Technical Service Bulletin

Mazda North American Operations
Irvine, CA 92618-2922

Subject: COOLANT LEAKS AT CYLINDER HEAD	Bulletin No.: 01-013/21
	Last Issued : 12/02/2021

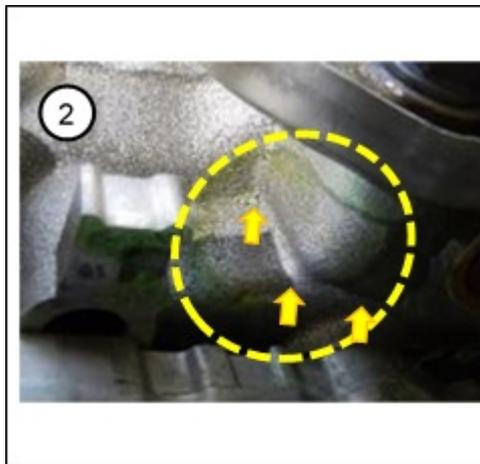
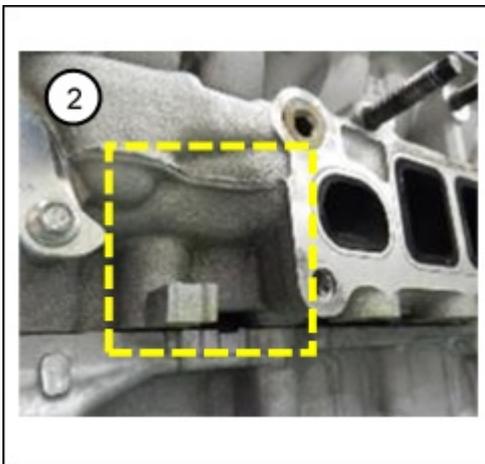
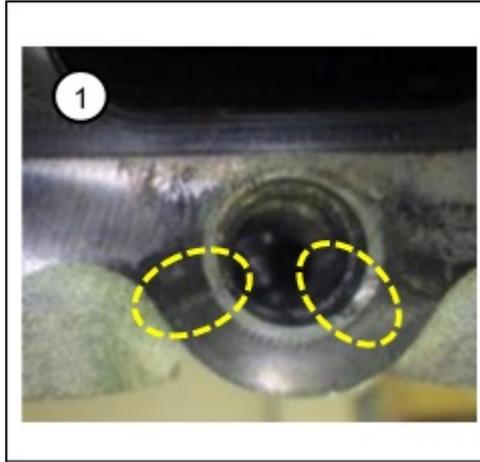
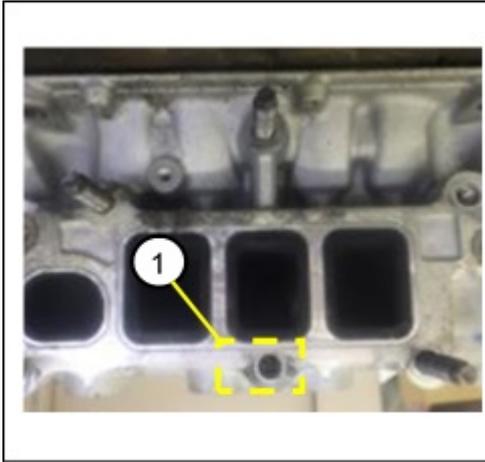
Some vehicles may have coolant leaks at the cylinder head around the exhaust manifold (as shown below). There may be cracks at the stud bolt hole (1) or at the outside of the exhaust manifold (2).

To eliminate this concern, the design of the exhaust manifold gasket and the cylinder head has been modified to reduce the force on the cylinder head.
